**CITY OF MOUNT AIRY
PUBLIC WORKS DEPARTMENT
ENGINEERING DIVISION**

RE: Addendum No. 1: Franklin Street Streetscape Phase I & Parking Lot Rehab

**MINUTES OF PRE-BID CONFERENCE
FRANKLIN STREET STREETScape PHASE I AND PARKING LOT REHAB**

DRAWING DATE: 13-Jan-26
SHEET NO. 6

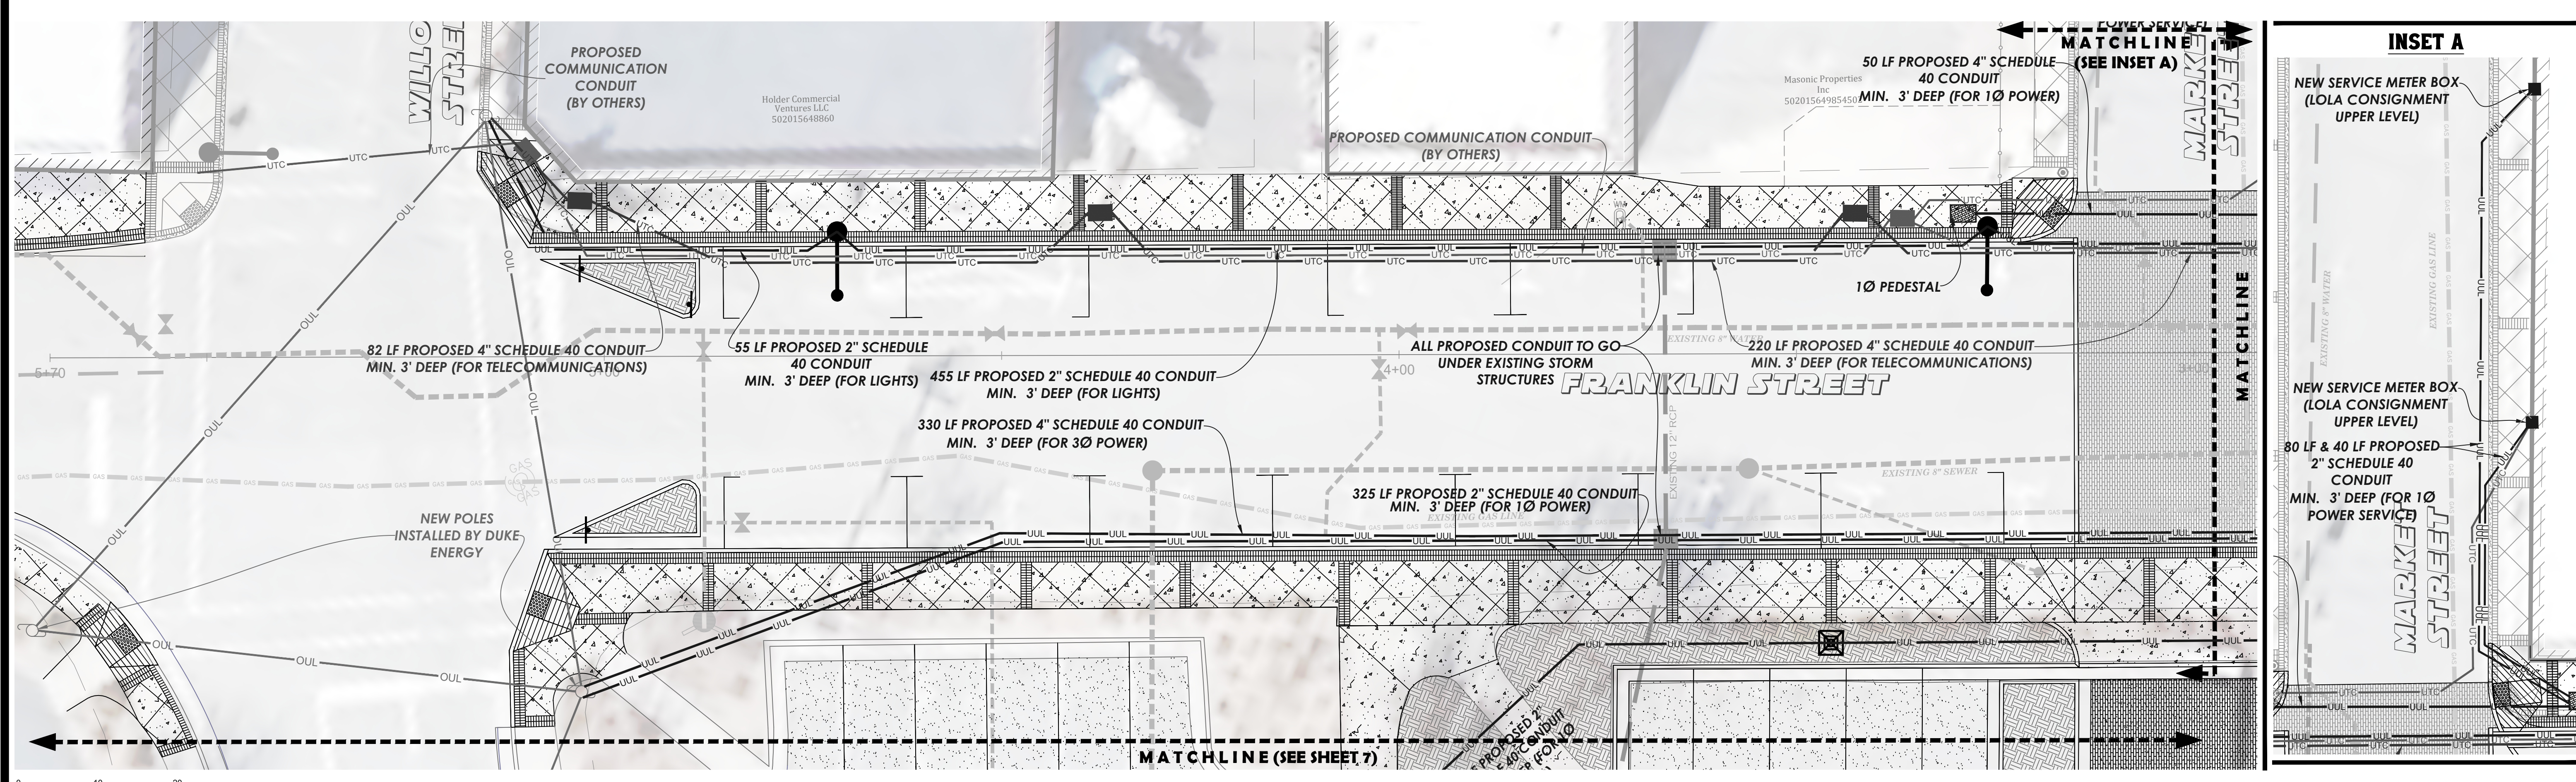
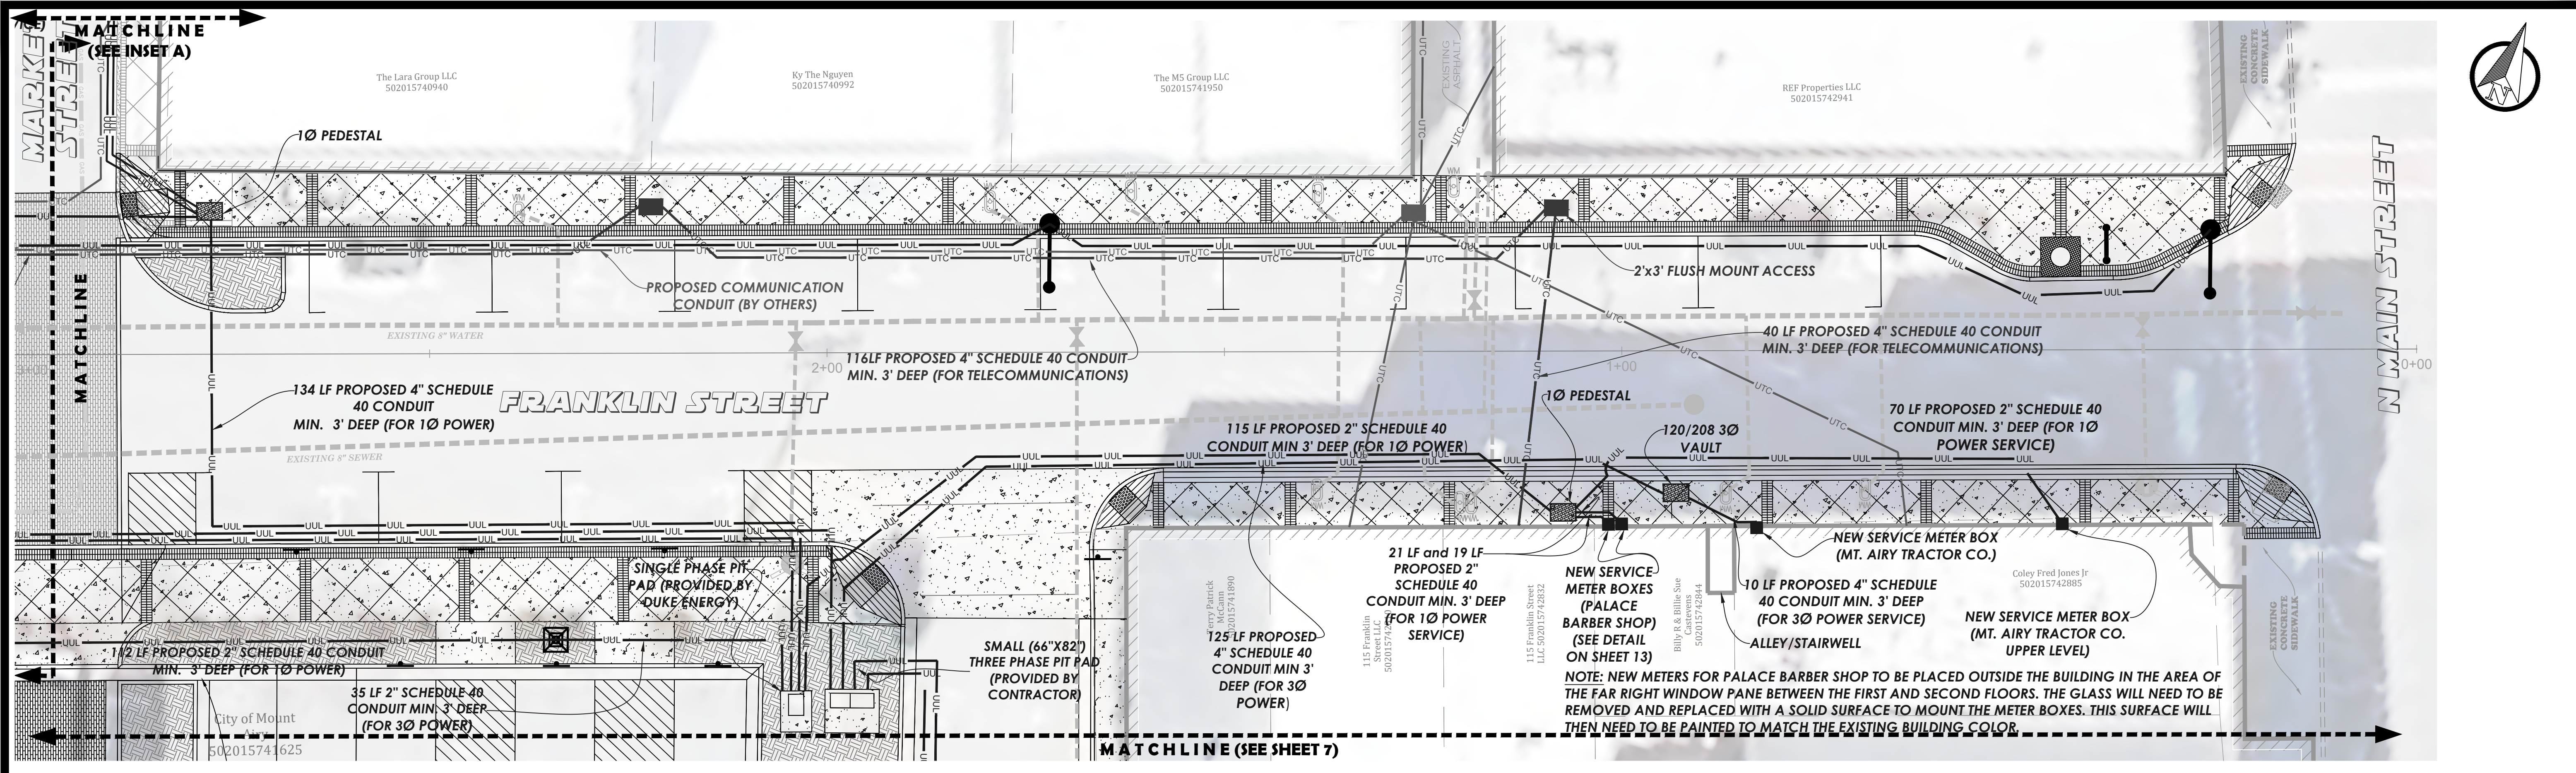
1. **Pre-Bid Conference:** An optional pre-bid conference was held on January 7, 2026 at 10:00 am at the Mount Airy Public Works building. Minutes of the pre-bid meeting are attached and shall be incorporated into this addendum.
2. **Clarifications/Modifications:**
 - a. **Palace Barber Shop Electrical Meter Locations:** There has been a change in the proposed location of new electrical meter boxes for Palace Barber Shop. The new meters will be installed in the area of the furthest right window right above the ground level (looking on from the street). Please see the updated plans and detail attached to this addendum.
 - b. **ADA Truncated Domes:** All truncated domes located at ADA ramps/transitions shall be brick truncated domes.

NO.	DESCRIPTION	DATE	BY
1	PALACE BARBER SHOP ELECTRICAL	01.13.2025	W.L.H

PALACE BARBER SHOP ELECTRICAL DETAIL
City of Mount Airy, North Carolina
Engineering Division
Post Office Box 70 Mount Airy, North Carolina 27030
www.mountairy.org

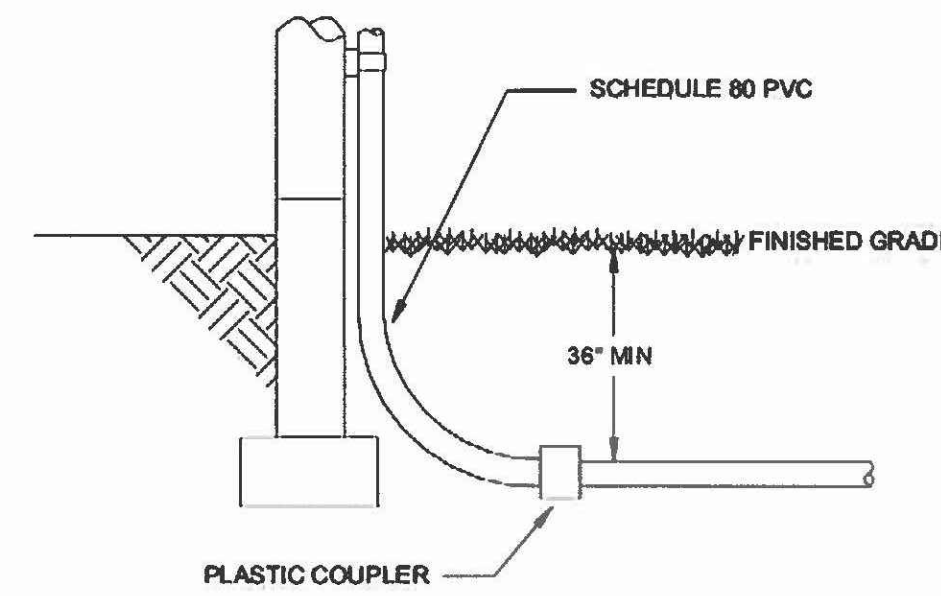
NO.	DESCRIPTION	DATE	BY
1	PALACE BARBER SHOP DETAIL	01.13.2025	W.L.H

CONDUIT FROM NEW METERS TO ENTER BUILDING USING EXISTING HOLE

EXISTING POWER ENTERING BUILDING (TO BE REMOVED BY DUKE ENERGY)

EXISTING GLASS TO BE REMOVED AND REPLACED WITH WOOD (WOOD TO BE PAINTED TO MATCH EXISTING WINDOWS)

PROPOSED 2 GANG METER BOX (MUST USE DUKE ENERGY APPROVED MANUFACTURER)

PROPOSED DUKE ENERGY JUNCTION BOX

PROPOSED 2-INCH CONDUIT

2-INCH CONDUIT STUB-OUT FROM THE STREET
